# Service Bulletin No. 277B

<b>MODEL</b> D4500 / D4505 Series Coaches	<b>TYPE</b> Field Change Program	<b>SECTION/GROUP</b> 12--Suspension	<b>DATE</b> Dec 17, 2007
<b>SUBJECT</b> FIXED TAG SUSPENSION MODIFICATION			
<b>CONDITIONS</b> CUSA D4500 / D4505 Series Coaches

**THIS BULLETIN SUPERCEDES FIELD SERVICE BULLETIN 277 IN IT'S ENTIRETY.**

Ref. NHTSA Recall No.: 06V-480 UPDATED

Figure 1.

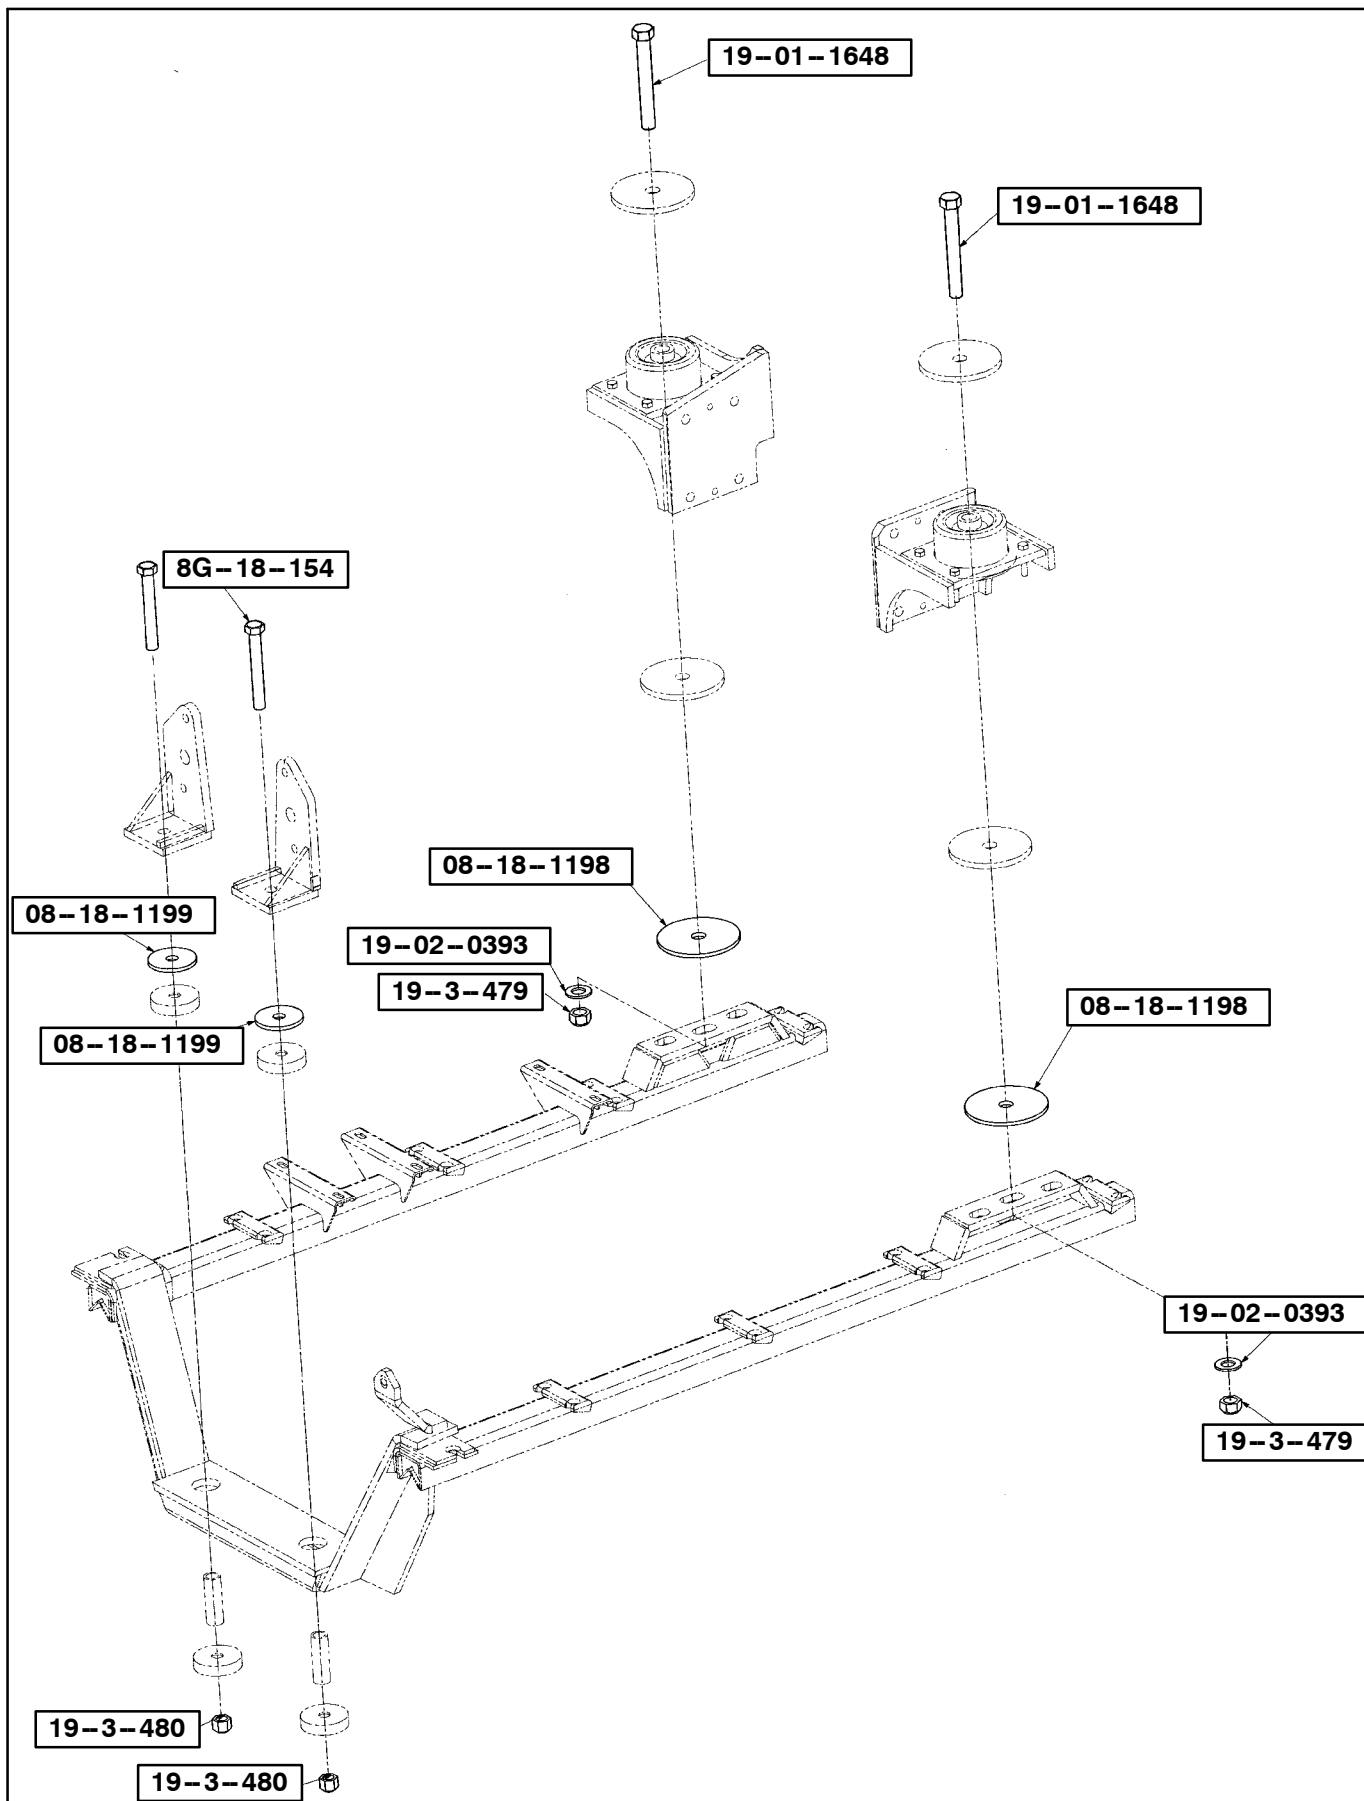
1. Turn the main battery disconnect switch to the “ OFF “ position. Chock both sides of the tires.
2. Open the engine compartment doors. Locate the engine remote and position the ENGINE RUN and ENGINE START to the OFF position.
3. Locate the engine cradle mounting hardware shown in Figure 1 ( four locations ).
4. Remove and discard the existing locknuts only from the four locations shown in Figure 1.

7. Remove and discard the existing fastener ( and washer if applicable ). Install appropriate shim ( p/n 08-18-1198 or 08-18-1199 ) and new mounting hardware provided in Parts list. Tighten nut hand tight only.
8. Repeat Step 7. to next fastener.

9. Upon completion of installing the four shims and mounting hardware, lower the jack removing all stress from the engine. Remove the jack from under the coach.
10. Torque 19-3-480 to 285–385 lbs.-ft. Torque 19-3-479 to 451–546 lbs.-ft.

Figure 3. Reference photo.

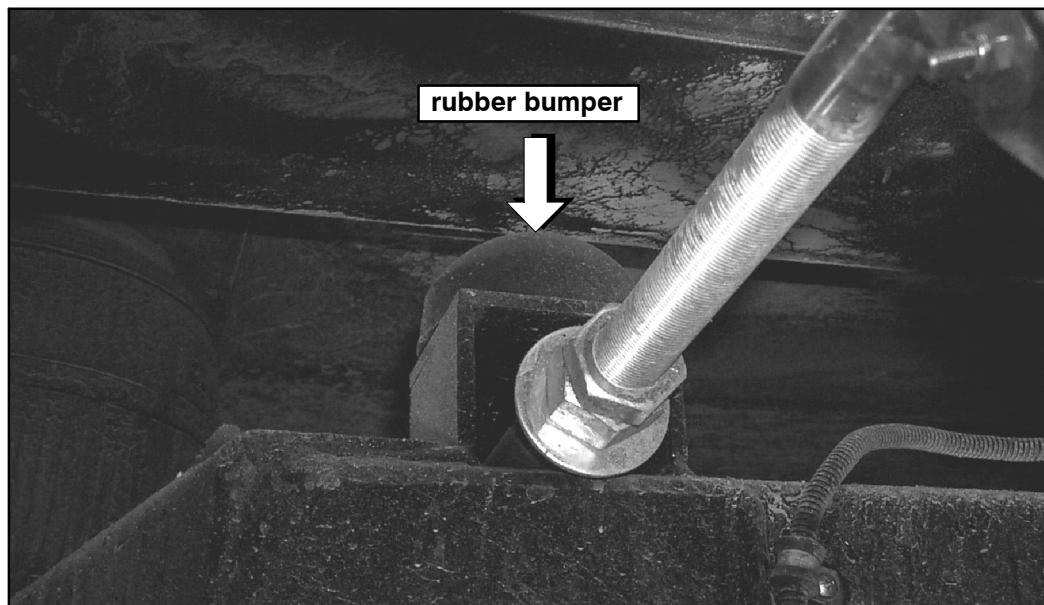
11. Locate the four existing rubber bumpers on the tag axle suspension assembly ( Figures 3 and 5 ).

12. Remove existing bumper assembly and discard. DO NOT re-use existing bumper.

**Figure 4. Reference photo.**

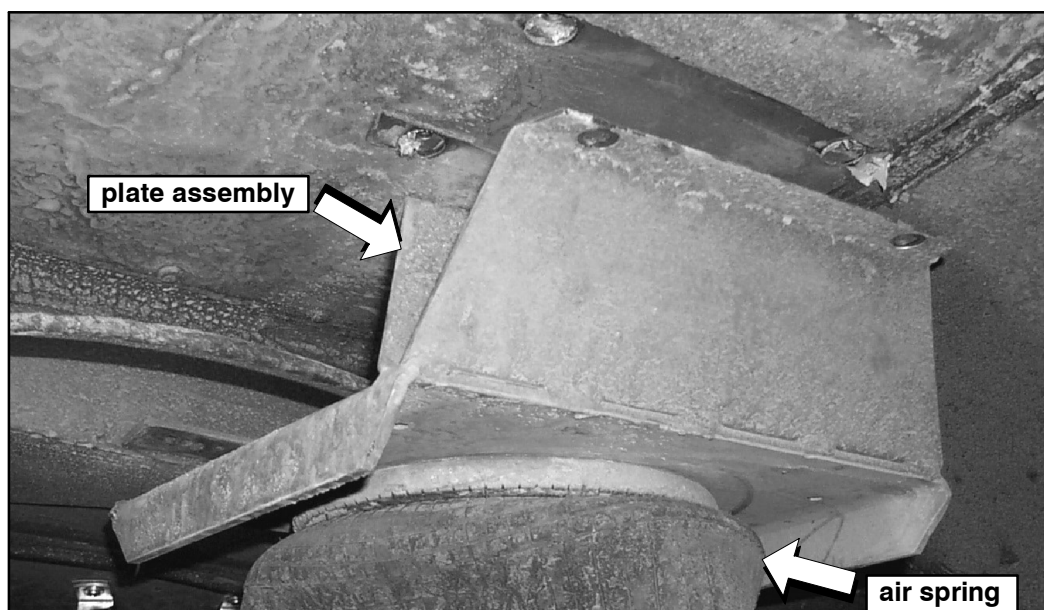
15. Remove and discard the plate assembly and mounting hardware ( Figures 4 and 5 ).

Figure 5.

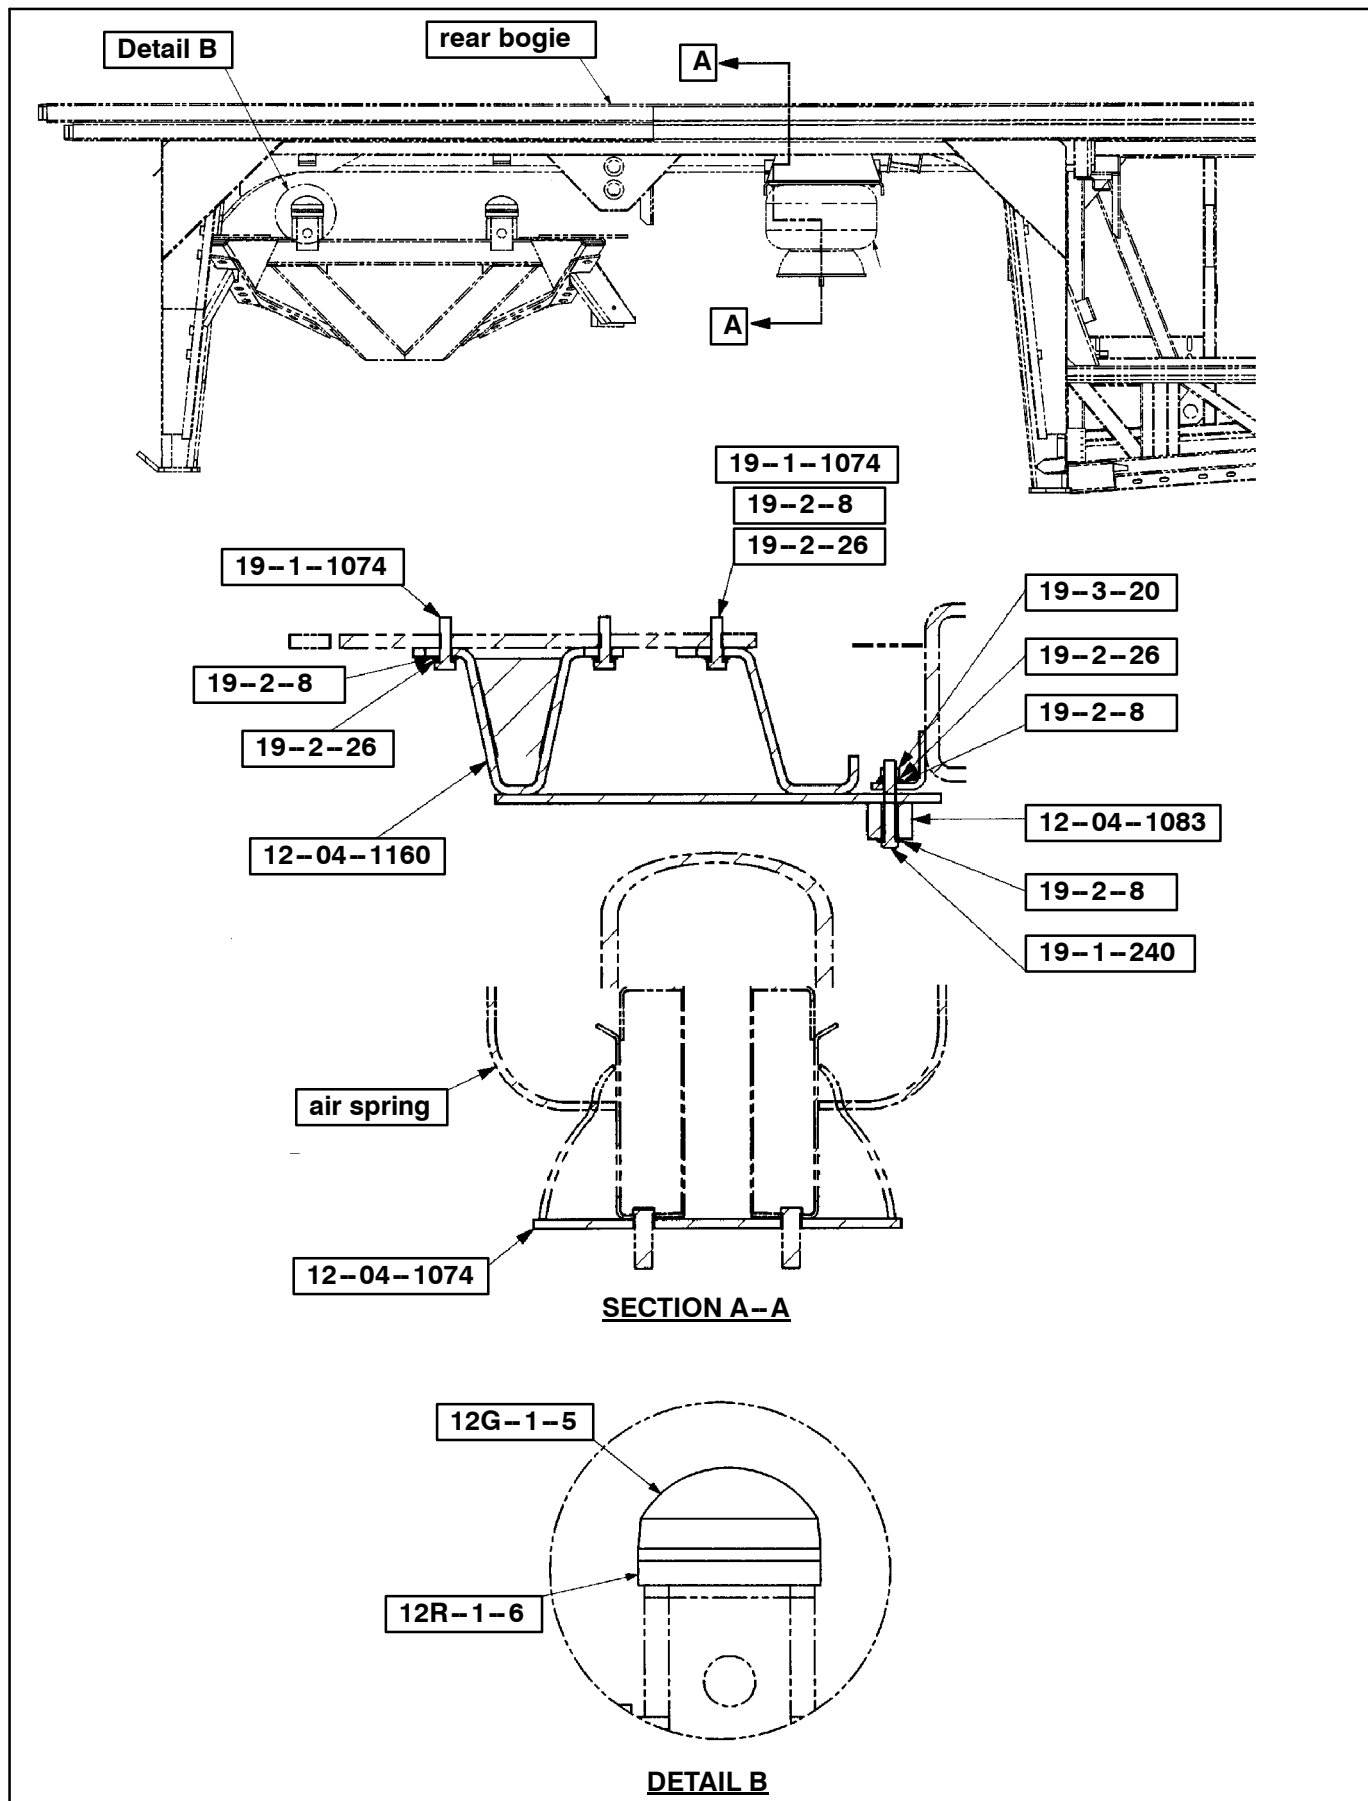
13. Disk sand the mounting surface in preparation of good reassembly.  
14. Install the new rubber bumper ( p/n 12G-1-5 ) and bumper block spacer ( p/n 12G-1-6 ) ( Detail B / Figure 5 ).

16. Install the new plate assembly ( p/n 12-04-1160 ) and spacer ( p/n 12-04-1083 ) in the locations shown in Figure 5., using the new plate assembly mounting hardware provided in the Parts list. Torque nut ( p/n 19-3-314 ) to 18–22 ft.-lbs.
17. Align and position the spacer ( p/n 12-04-1074 ) in the location shown in Figure 5.
18. After the coach has been lowered to the ground and lifts removed, return the tag axle dump valves to the ON ( horizontal ) position. Close the curbside, rear service department door.
